1433 Baldwin St.
Burlington

Project Description:
Interior renovations including: relocation/renovation of existing office space, provision of new Universal Washroom. Also, there will be a replacement of some existing windows.

**Re: Burlington Central High School Renovations
1433 Baldwin Street**

Permit Clarifications:

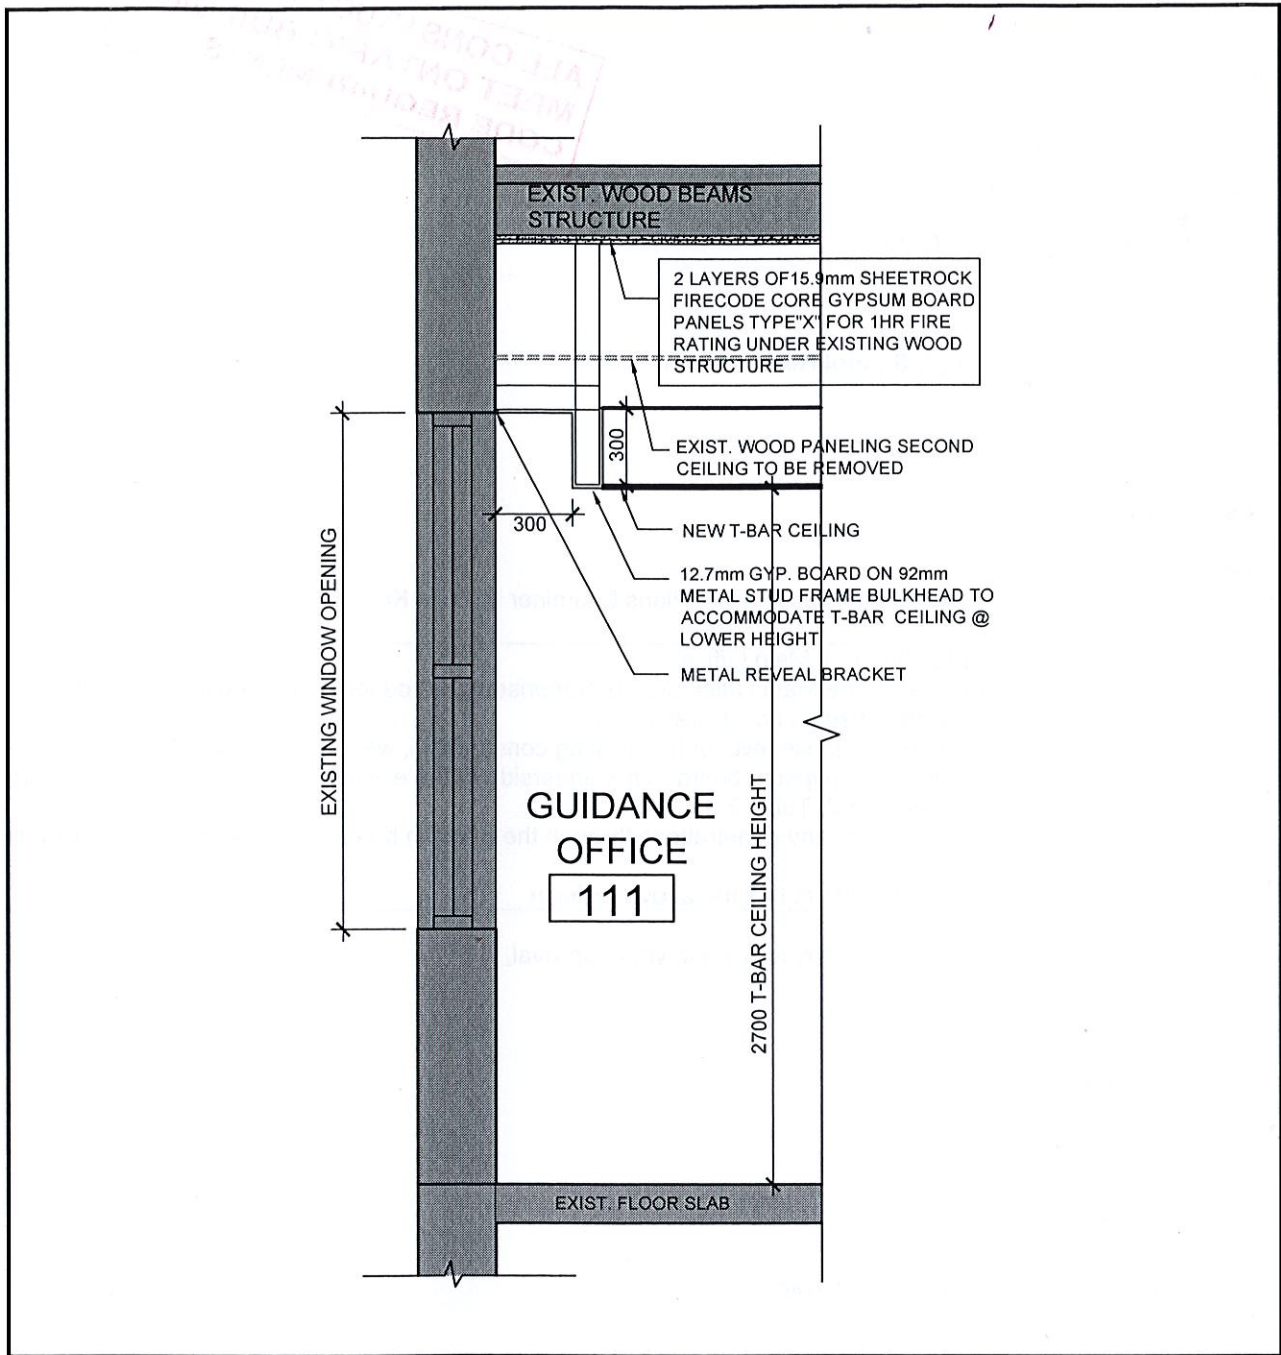
1	<p>Fire Rated Ceiling Membrane at Main Office Area The existing 2nd floor above the Main Office area is comprised of wood joists. The existing acoustic tile ceiling (which is being removed) is not fire rated. In order to exceed the performance level of the existing construction, we propose to install 2 layers of 16mm thick, Type X fire rated gypsum board to the underside of the existing wood joists to get a 1hr fire rating, in accordance with SB-2, Table 2.3.4.B. As already noted on the dwgs, any penetrations through the gypsum board membrane will be firestopped. Refer to attached dwg SKA 101 noting the above revision.</p>
---	---

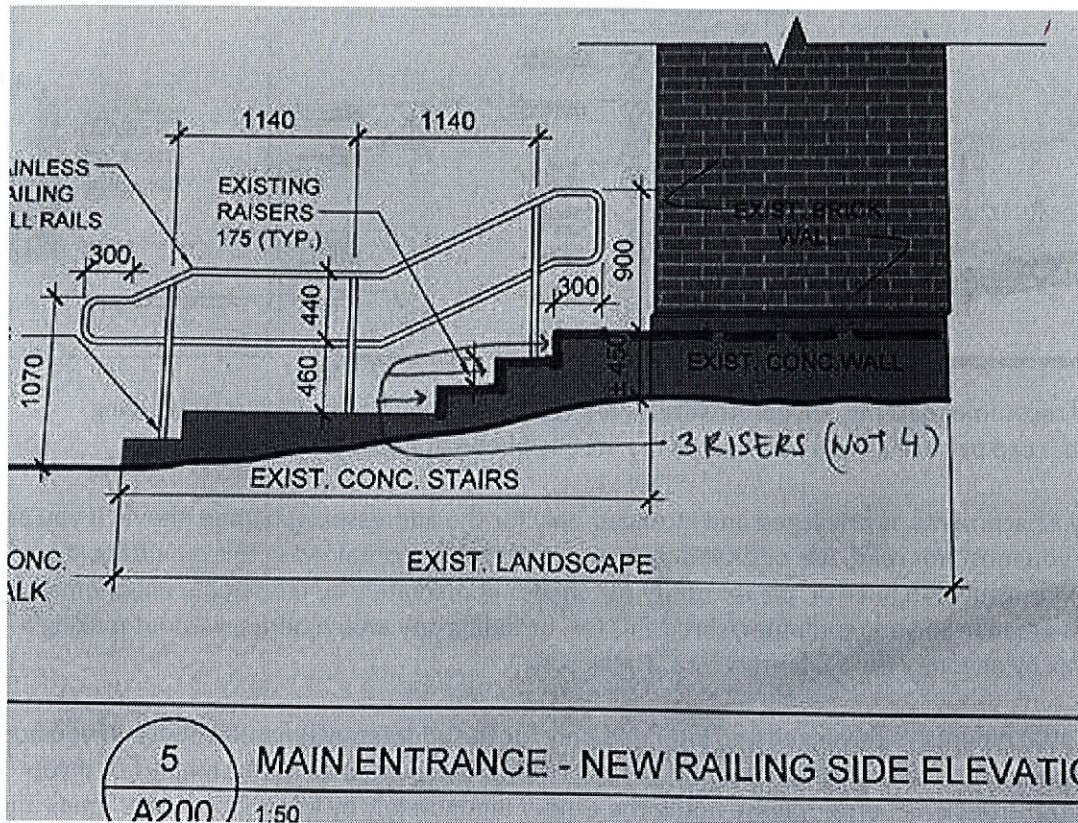
2. The section 5/A200 (we discussed) indicates approx. 175 mm existing riser the drawings indicates 450 mm landing height but if you calculate 4 riser x 175 mm = 700 mm so if you are proposing handrail then it shall be proper Guard with pickets and handrail. But if you are not touching existing condition then I cannot ask. If proposed design is required then you can send sealed sketch only and shop drawings can be submitted to inspector by adding note to sketch. There are only 3 risers, not 4 - see marked up dwg in red - so we are under 600mm.
